WATERBURY FILING NO. 1
GRADING EROSION CONTROL PLAN
INITIAL EROSION CONTROL PLAN 2

GRADING EROSION & STORMWATER CONTROL PLAN
INTERIM EROSION CONTROL PLAN 2

WATERBURY FILING NO. 1

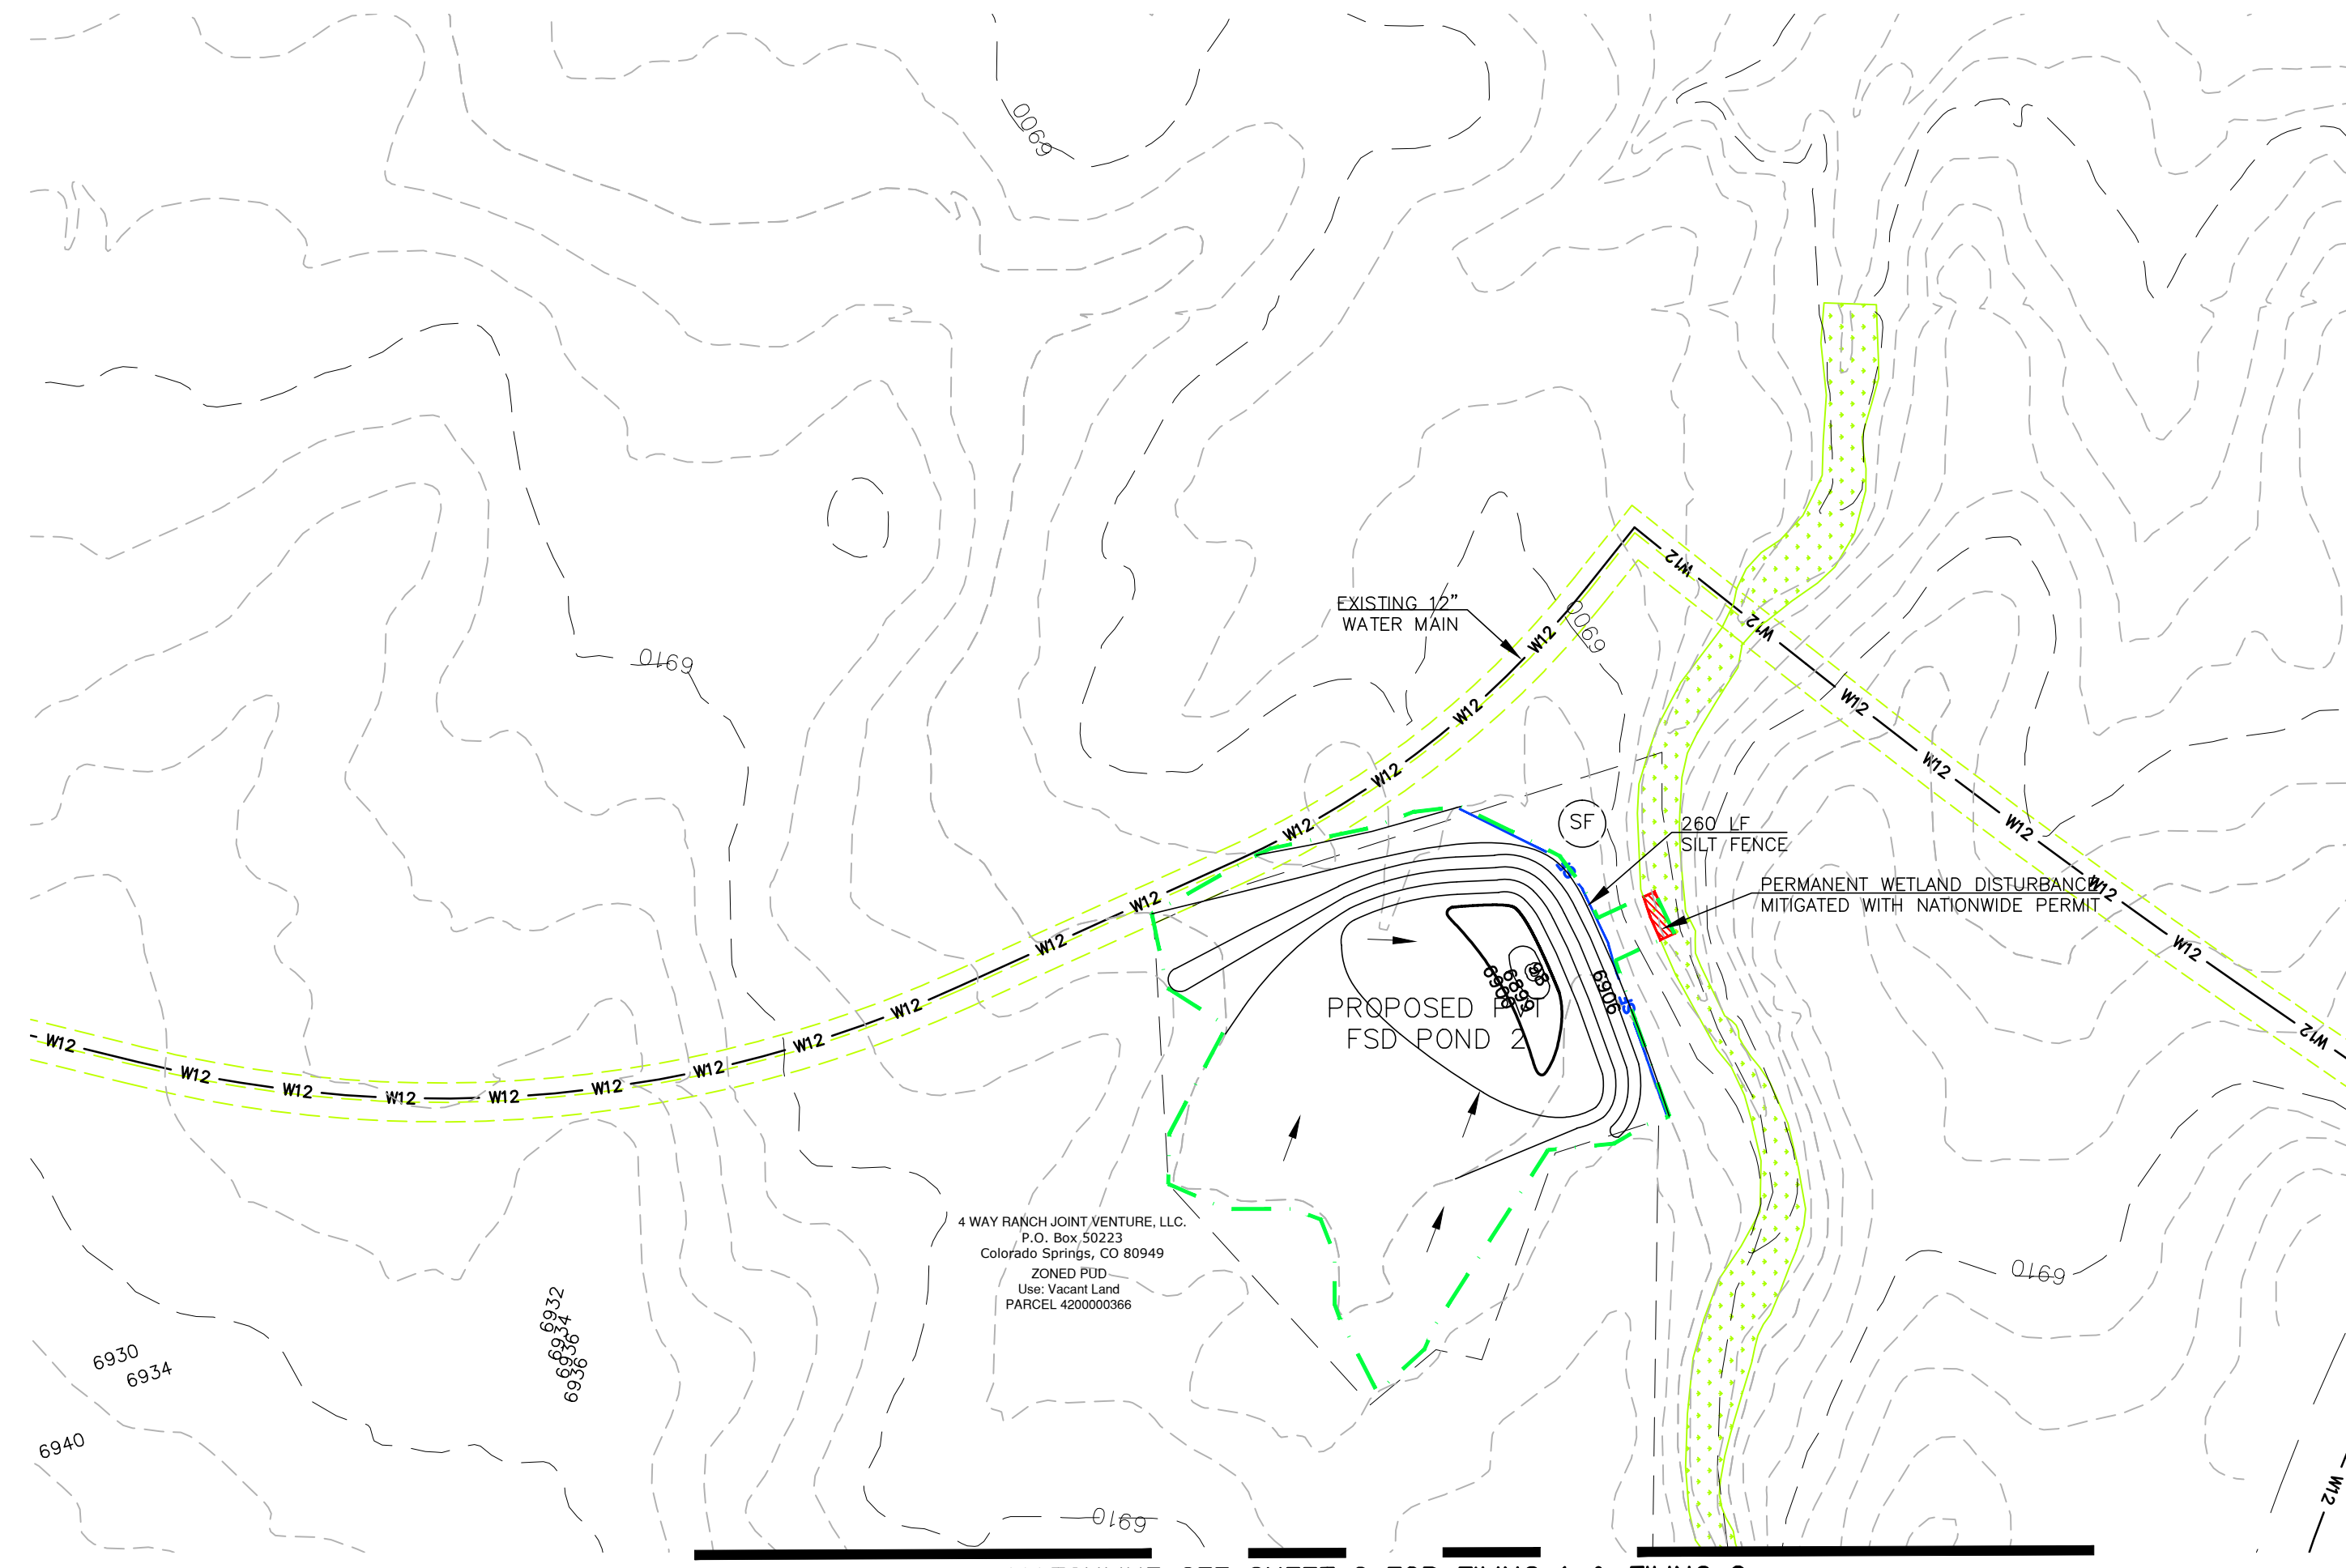
ESTIMATED AREA OF DISTURBANCE = 69.00 ACRES

REVISED TO 72.46

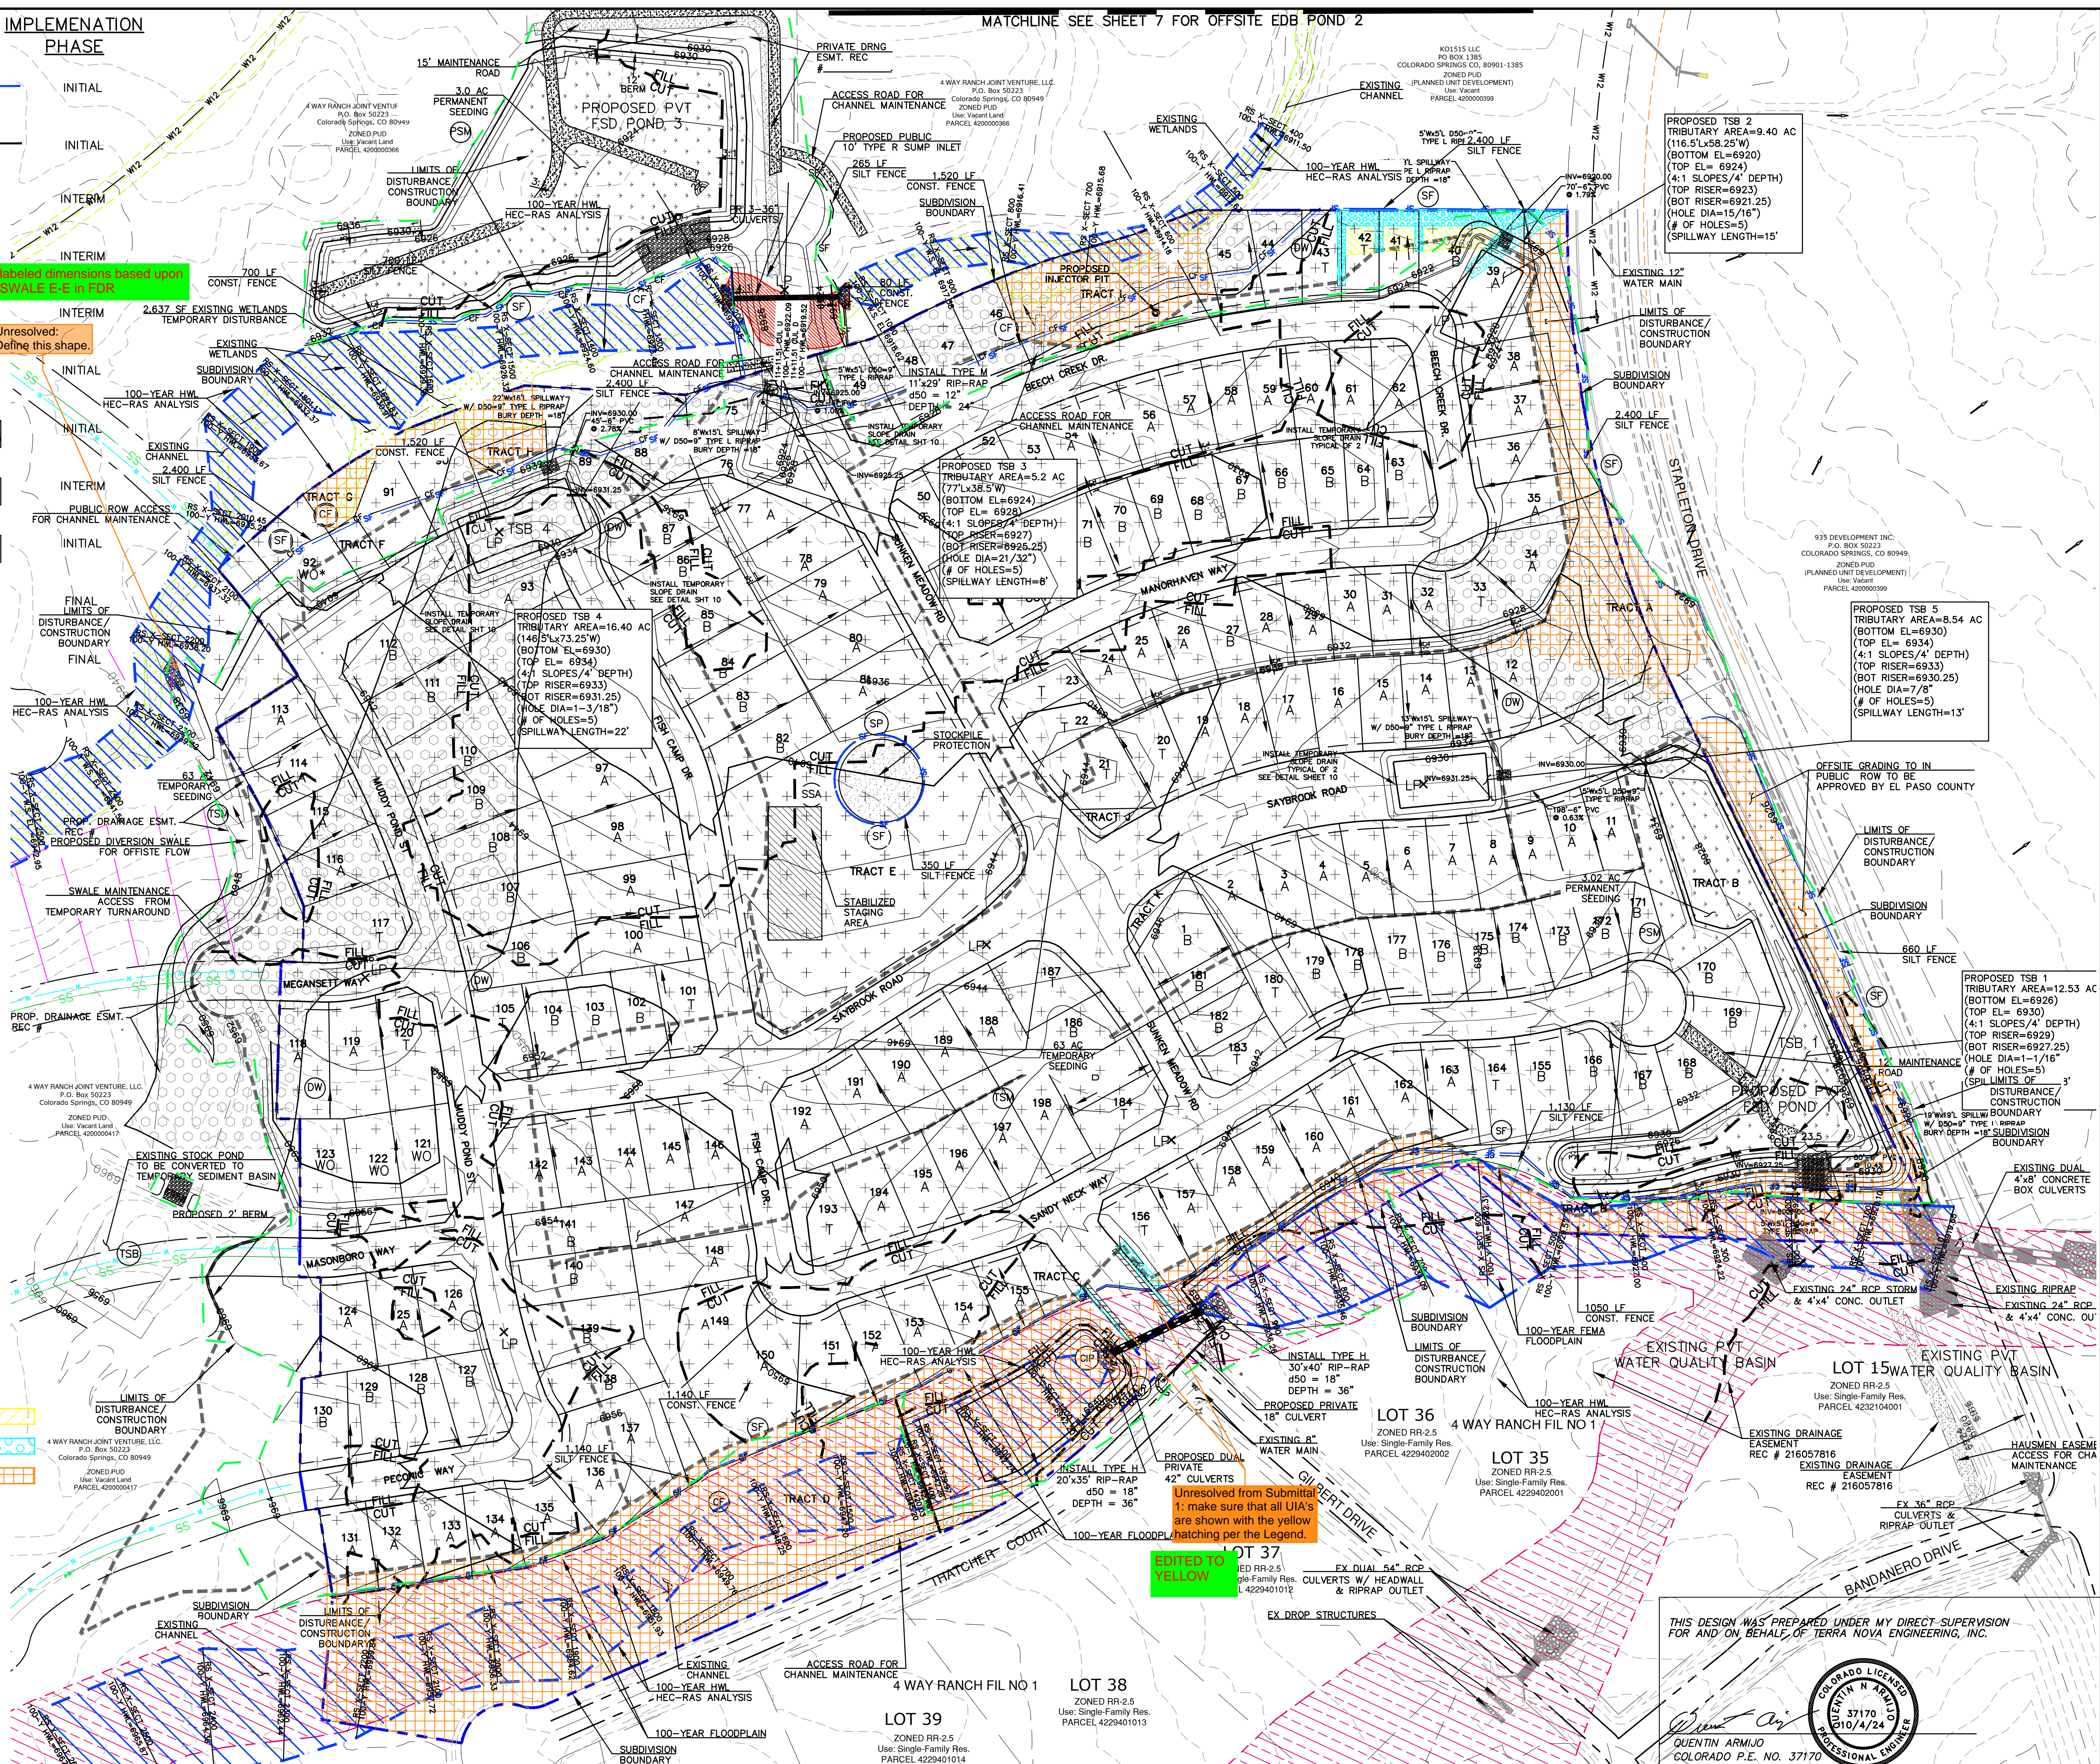
Unreviewed from Submittal 1, make sure that all UIAs are shown with the yellow hatching per the Legend.

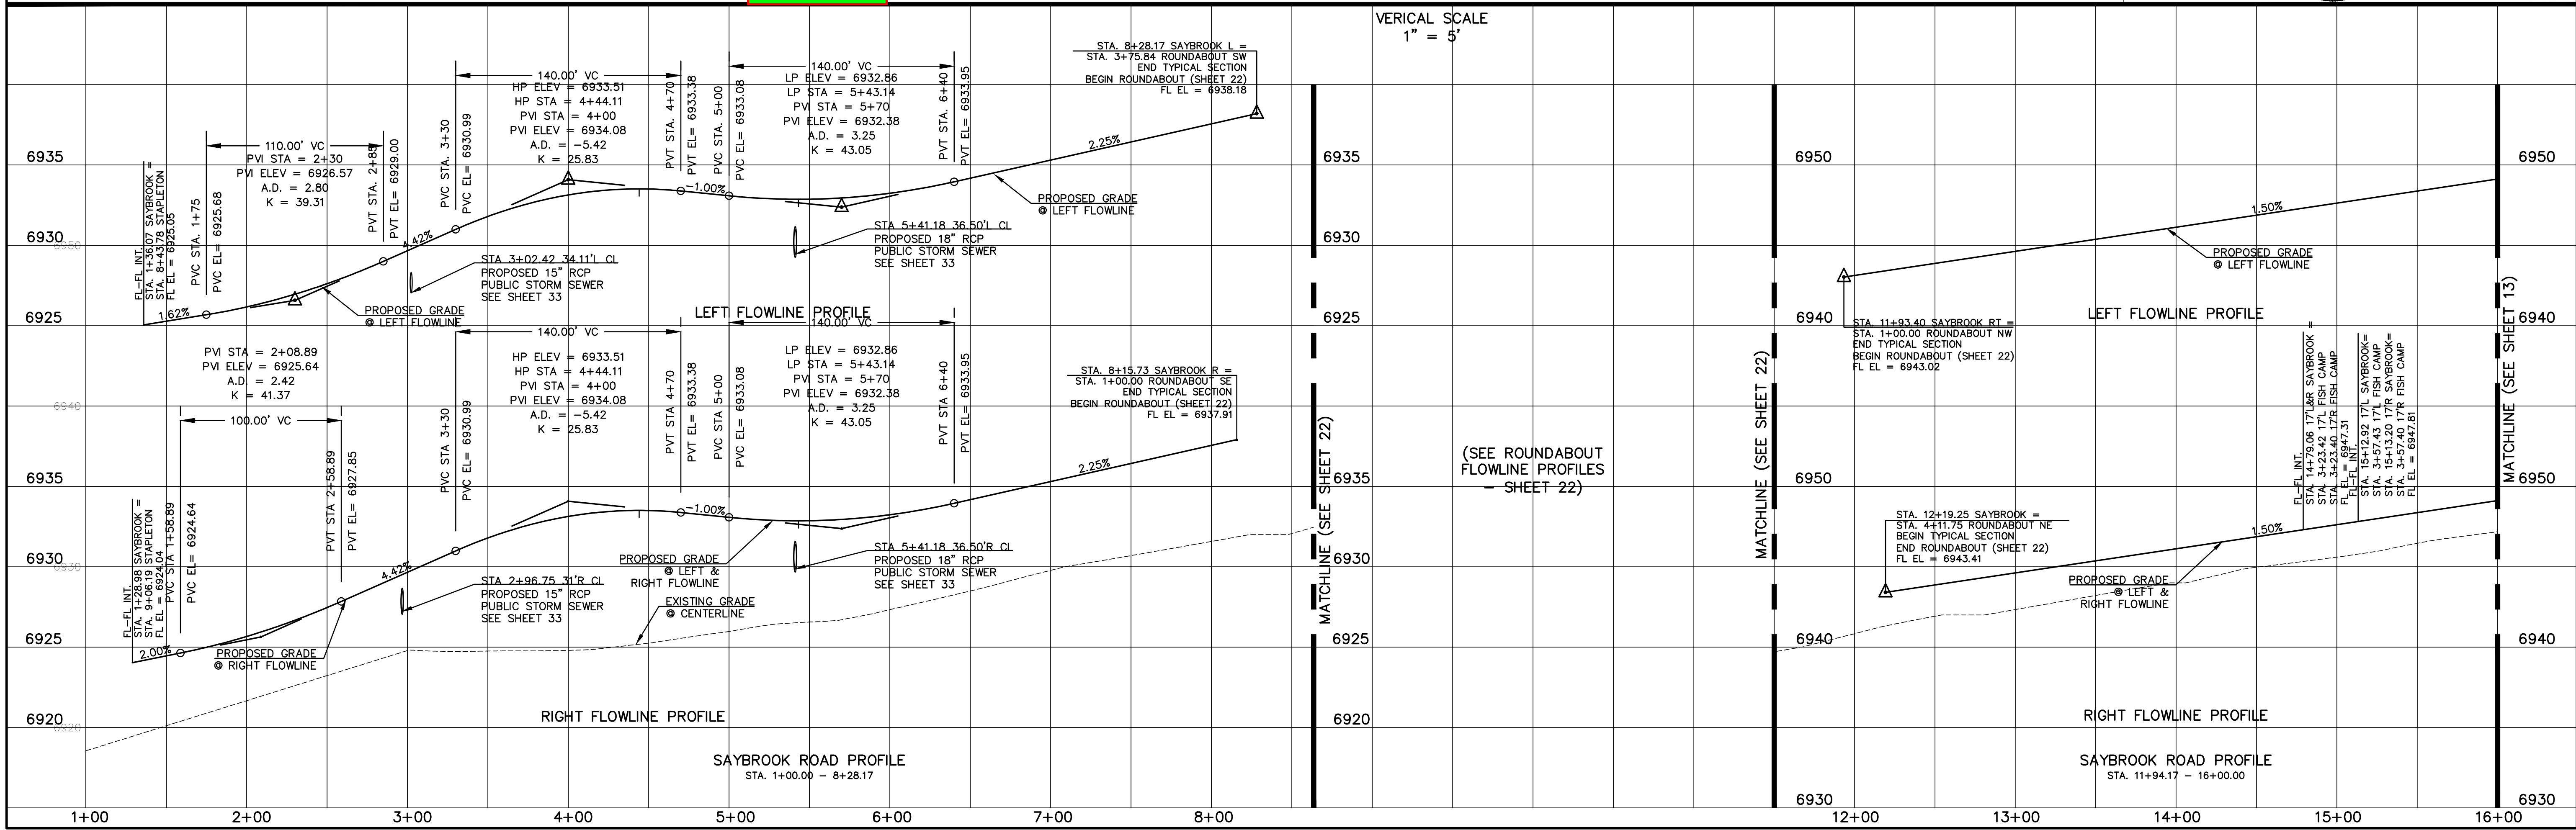
Provide reference to sheet with specific details on groundwater/soils mitigation at the south end of Saybrook.
